INTRODUCTION

This Final Environmental Impact Statement (FEIS), prepared pursuant to the State Environmental Quality Review Act (SEQRA), provides responses to agency and public comments received by the lead agency on the Draft Environmental Impact Statement (DEIS) prepared for the Stateline Retail Center project, Town of Southeast, Putnam County, New York. The FEIS has been prepared in accordance with Section 8-0101, et. seq. of the Environmental Conservation Law and the regulations promulgated by the New York State Department of Environmental Conservation (NYSDEC) thereunder, which appear at 6 NYCRR, Part 617.

Summary of Proposed Action

Figure I-7: DEIS Plan/FEIS Plan Overlay
 Stateline Retail Center
 Town of Southeast, Putnam County, NY
 Source: Insite Engineering, Surveying & Landscape Architecture, P.C.
 Drawing Dates: 11/24/08 (FEIS), 04/18/08 (DEIS)
 Scale: As shown

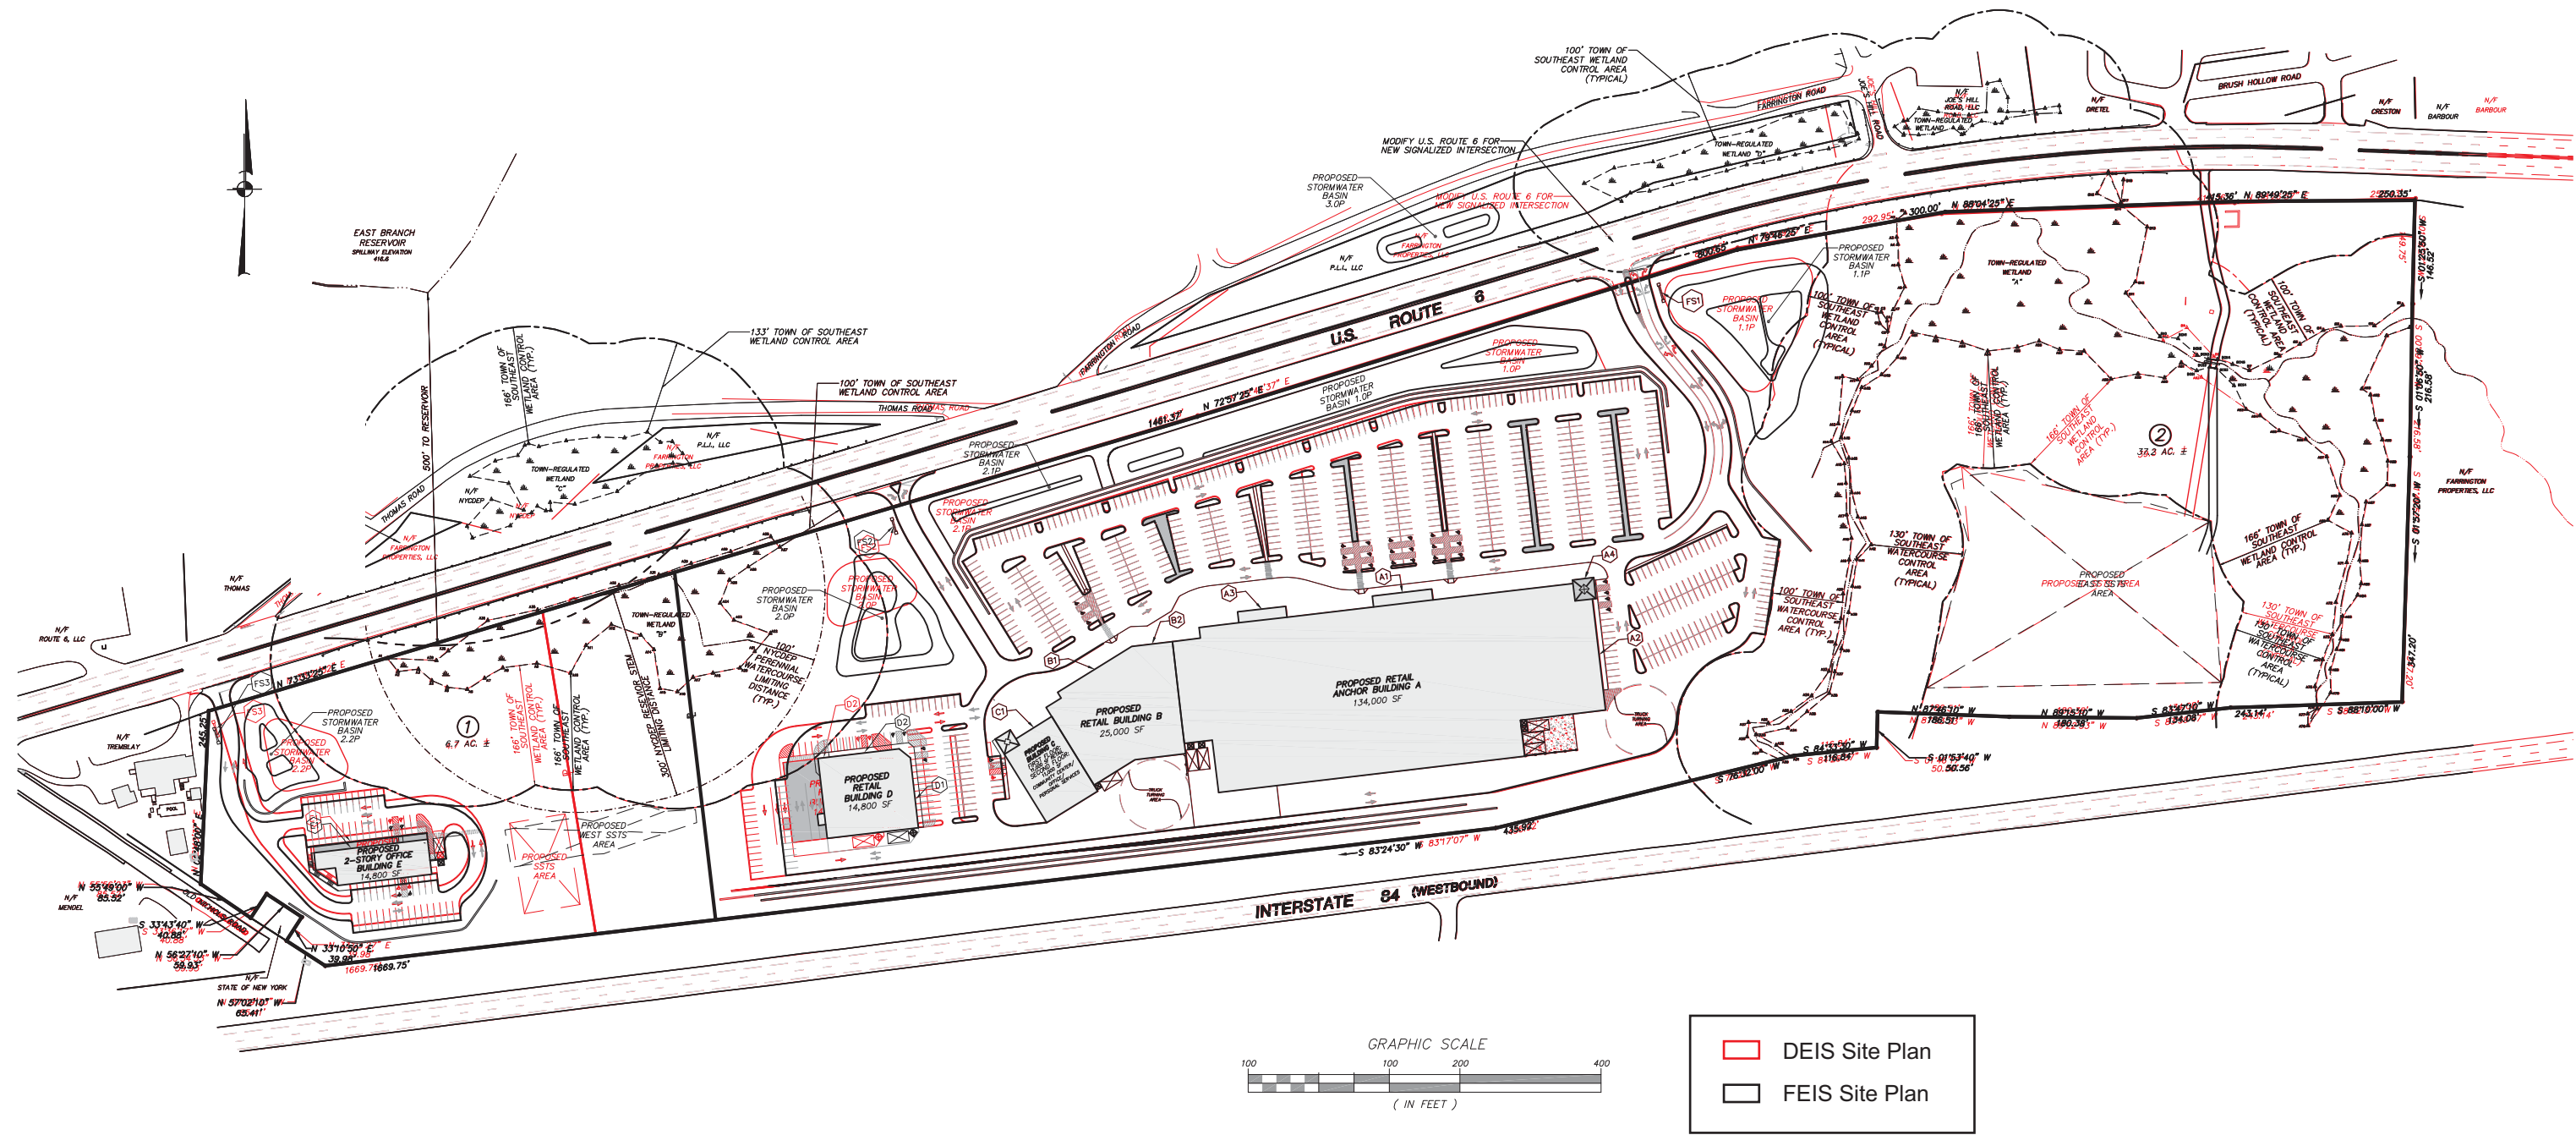
The changes made to the site plan in response to comments and concerns expressed by agencies, the Town, its consultants and the public include:

1. The stormwater management practices have been modified in shape and increased in size to meet the requirements of Chapter 10, Enhanced Phosphorus Removal Standards, from the New York State Stormwater Management Design Manual.

2. A pedestrian trail connecting Lot 1 and Lot 2 has been added.
3. Buffer disturbance has been reduced: Building D was shifted further east and some of the parking spaces between Building C and Building D have been eliminated.

- a. Building E was shifted further south and the access to Building E was shifted further west eliminating activities in the wetland control area.
 - b. Stormwater basin 2.2 was reconfigured as was the access road on Lot 1. This eliminates disturbance to the wetland control area. Only the outlet structures remain in the control area.

- c. Stormwater Basins on Lot 2 were modified.
4. Pervious pavement has been added in the northwest corner of the access road and parking for Building D.

5. Pavement to the east of Building D has been reduced by eliminating parking spaces.
6. Proposed US Route 6 improvements to accommodate the main site entrance have been added.
7. Stormwater basin on the north side of US Route 6 to treat the runoff from the proposed US Route 6 improvements has been added.
8. Depressed islands and bioretention areas in the parking areas in front of Buildings A, B and C have been incorporated into the project plans.
9. An irrigation tank at the rear of Building A is now included in the plan.
10. The basemap has been updated to include survey data for US Route 6 and several properties on the north side of US Route 6 from the subject property.
11. The proposed lighting and landscaping on Lot 2 have been revised to accommodate the adjunct stormwater practices.

Figure I-7 overlays the FEIS plan on the DEIS plan to highlight the site plan changes made since the acceptance of the DEIS.
